**2020 Dead End Water Main Elimination Project**  
**Solicitation Number: CO-00411**  
**Job No.: 20-4001**

**ADDENDUM #1**  
**May 20, 2021**

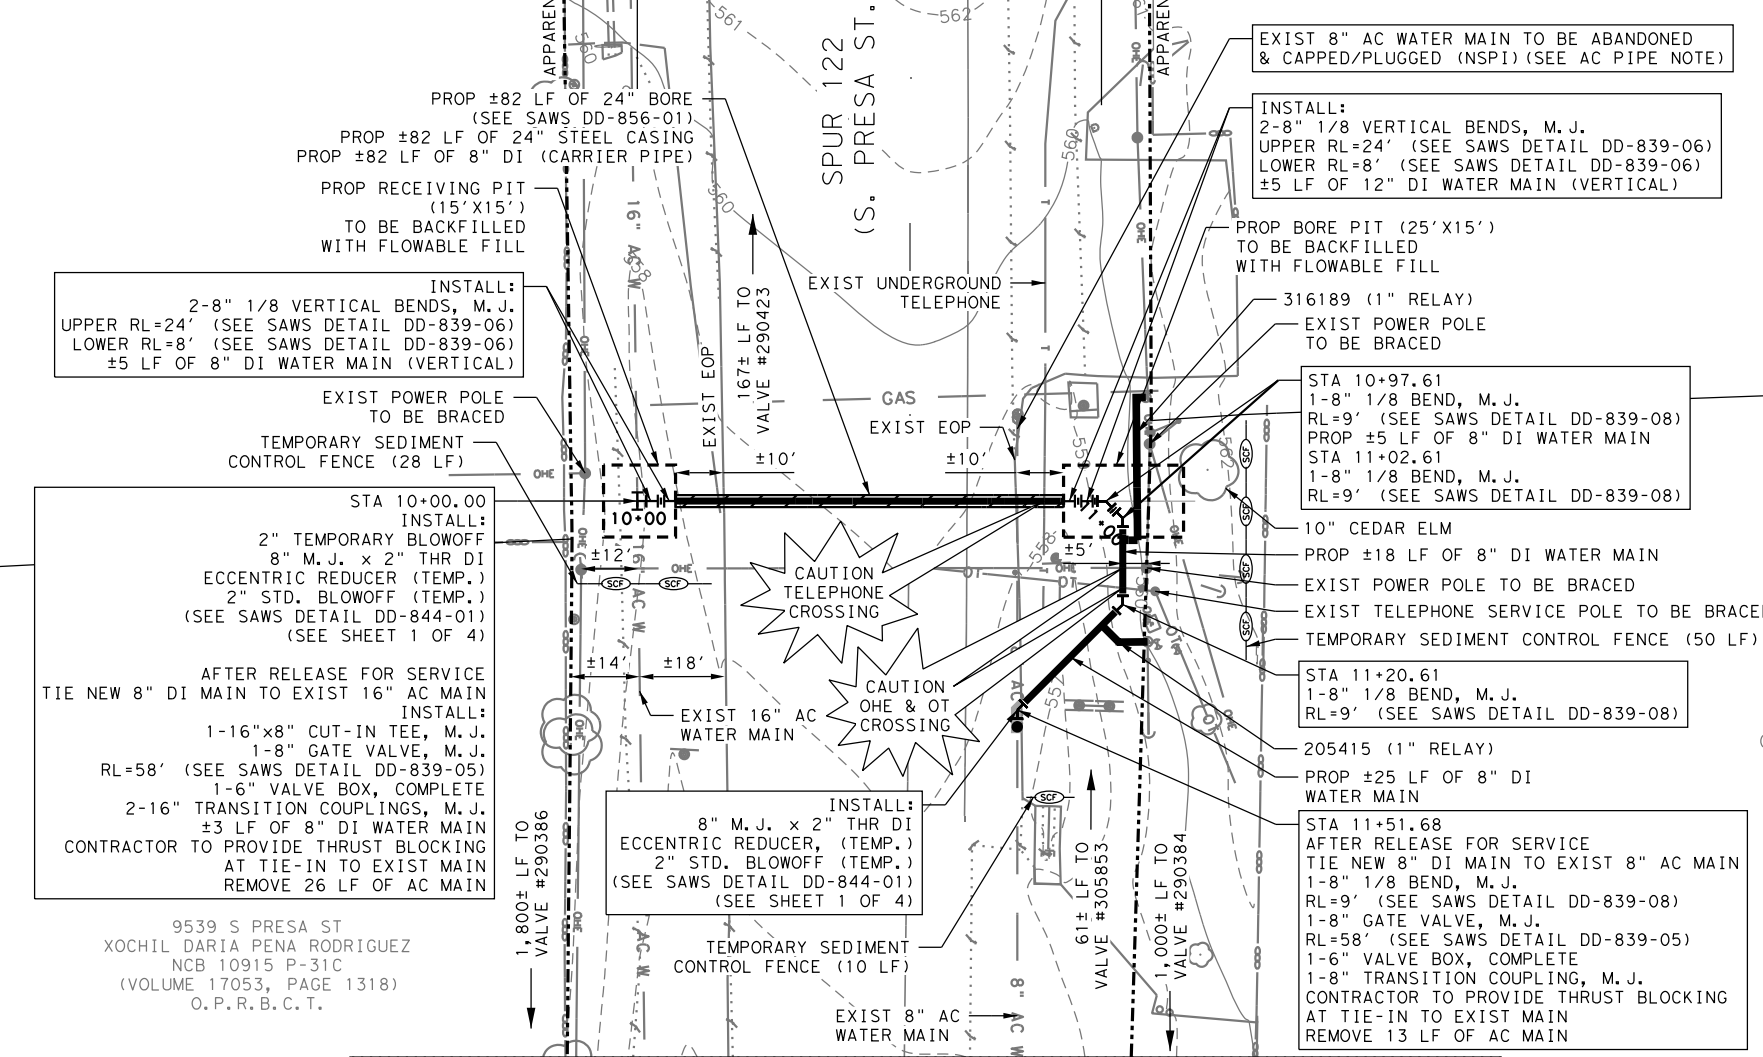
**7. Question:** Please clarify if Note 7E on plan sheet 4 "The contractor shall have an additional crew on stand by for each tie-in specified in the notes/specs at no additional expense to SAWS". Does this apply to any of the tie-ins on this project and if yes, please specify which tie-ins it applies to. I have never seen this note before.

1. Plan Sheet 4 of 70: Delete the Note 7E under Tie-in, Shutdown & Sequencing Notes.
2. Plan Sheet 20 of 70: Replace Item No. 502 in the quantity table as 240 in HR units.

*Response:* This note does not apply to any of the tie-ins on this project, therefore, this note will be omitted.

DEAD END MAIN ELIMINATION  
 SITE 2 - WATER PLAN

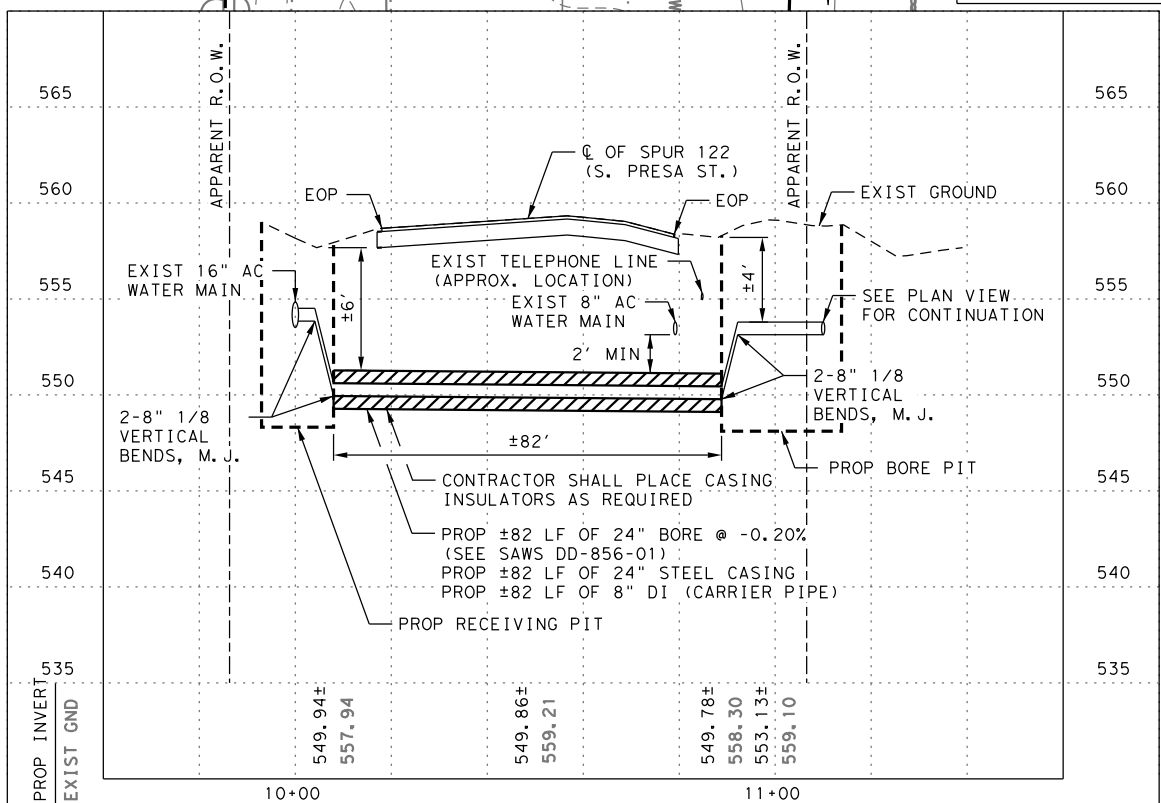
**8. Question:** Regarding the above referenced project bid item No. 22 Barricades, Signs and Traffic Handling has a quantity of 240 in HR units. Plan Sheet 20 of 70 has a bid item list that includes bid item No. 22 with quantity of 1 each. Please confirm if item No. 22 in the bid proposal is to have a quantity of 1 EA.

*Response:* The quantity for item No. 22 in the Bid Proposal is 240 in HR units. Change to the Item 502 in the quantity table located on Sheet 20 of 70 will be updated to reflect bid item No. 22 (240 HR units).
